EC Series Electrical System Mandatory Product Improvement

Trans/Air Manufacturing maintains a policy of continuous improvement of our products and services. In keeping with this philosophy, Trans/Air is issuing Mandatory Product Improvement 09-002, to address the following key areas of concerns in the aftermarket installation of Trans/Air EC series electrical Climate Control Systems.

Trans/Air has developed a product improvement kit p/n 5031234 for EC2.0 & EC2.5 and kit p/n 5031233 for EC3.0

Fig 3

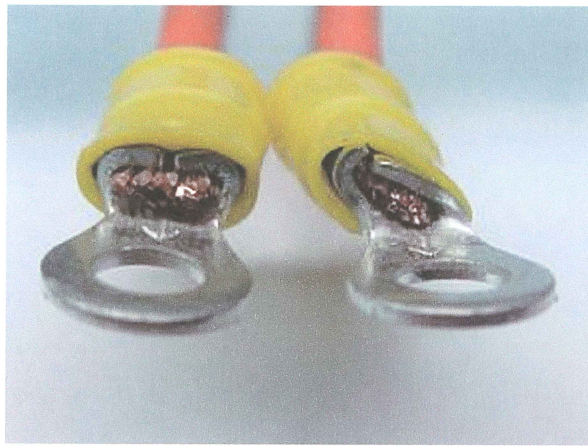
3. All screws on the terminal strip should be replaced with the Torx type screw, supplied in the product improvement kits for EC2.0, EC2.5 & EC3.0, and ***MUST BE*** torqued to 18 in/lbs. (a torque screwdriver is available on a loan basis, from Trans/Air) (Fig 3)

Torque all Torx type screws to 18 in/lbs

Fig 1

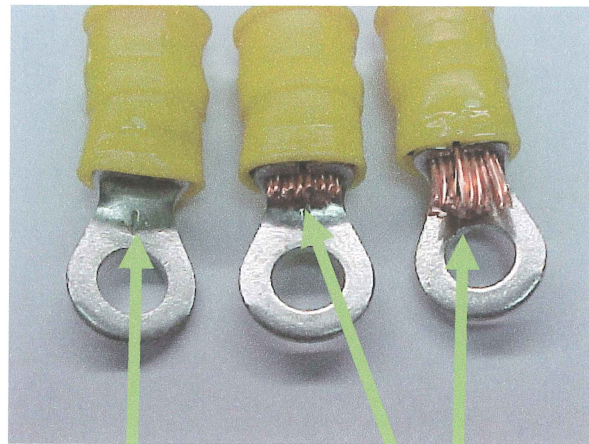
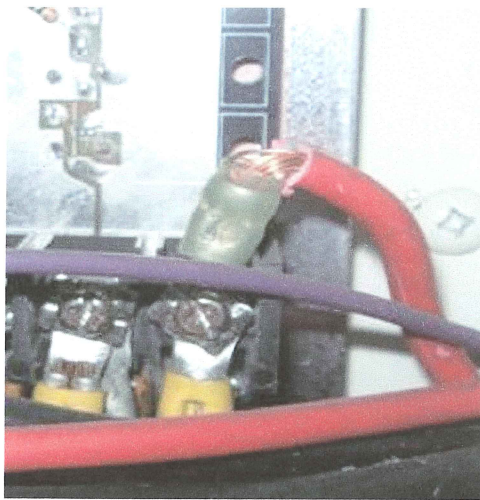
1. Crimps on the wires going to the terminal strip of the relay board should be uniform and tight. There should be no bare wire visible between the wire insulation and the terminal, and strands flush with terminal barrel. (Fig 1 & Fig 2)

Fig 4

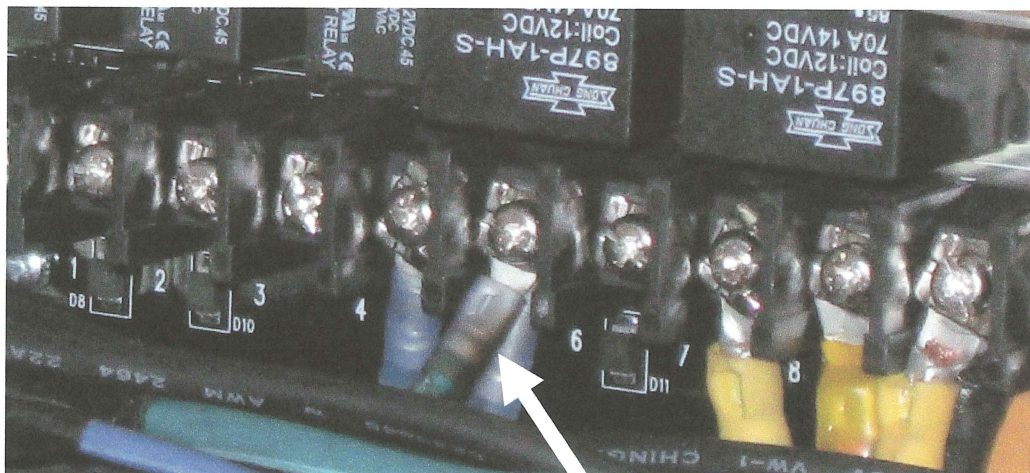
Heat discoloration of a poor (loose) crimp
